HESSD

Interactive comment on "Which rainfall metric is more informative about the flood simulation performance? A comprehensive assessment on 1318 basins over Europe" *by* Stefania Camici et al.

Received and published: 8 June 2020

Figure 1. Relationship between basin area and KGE-Q for the analysed catchments.

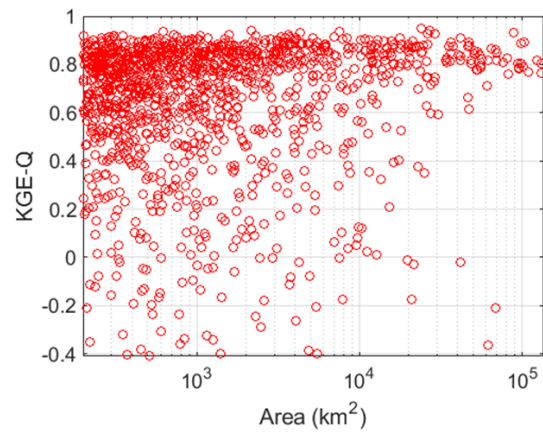
1. Line 158-169: the E-OBS dataset is built on a station network with an average station density of 1 in 4000 km2 and the basin areas range from 200 to 136'000 km2. Is the E-OBS dataset a reliable benchmark for the smaller basins? Maybe it is worth to discuss this in your discussion section.

R: In the submitted version of the paper, an error occurred in the definition of station used within the E-OBS datasets. Indeed, 2316 stations (i.e., equivalent on average to a density of 1 station every 4000 km2) is referred to the first versions of E-OBS whereas

in the version 17 (used in the manuscript) the number of stations increased up to 9618 (equivalent on average to a density of 1 station every 1000 km2). However, as correctly raised by the reviewer even the E-OBS density network referred to version 17 could be too low to correctly represent the rainfall spatial variability over small basins. This, in turn could affect the discharge simulation. To consider this aspect, it has been verified that 1) for all the analysed basins the KGE-Q values obtained by the calibration of the model by using E-OBS dataset as input were greater than -0.41, i.e., the model improves upon the mean flow benchmark 2) no relationship between basin area and KGE-Q exists (see Figure 1). As these conditions were satisfied and as the purpose of the study was to investigate the performances between rainfall and discharge time series (without specific focus on high and/or low flows), the limitations about the E-OBS station density can be assumed to have a negligible impact for the analysis purpose.

Accordingly, two sentences will be added in the revised version of the manuscript (on section 5.2): "The results of this calibration, carried out for the entire observation period (2007-2016), are good as illustrated in Figure 3a: for all the analysed basins the KGE-Q values are greater than -0.41, i.e., the model improves upon the mean flow benchmark and the median KGE-Q value obtained for the European area is equal to 0.768 (0.770 over the TMPA area). In addition, to take into account that due to the density network, E-OBS rainfall data could be not reliable for smaller basins (area<1'000 km2) the relationship between basin area and KGE-Q has been investigated (not shown). As no relationship was found, and as the purpose of the study is to investigate the performances between rainfall and discharge time series (without specific focus on high and/or low flows), the limitations about the E-OBS station density can be assumed to have a negligible impact on the analysis results and QE-OBS data can be assumed as a good benchmark for the successive analysis."
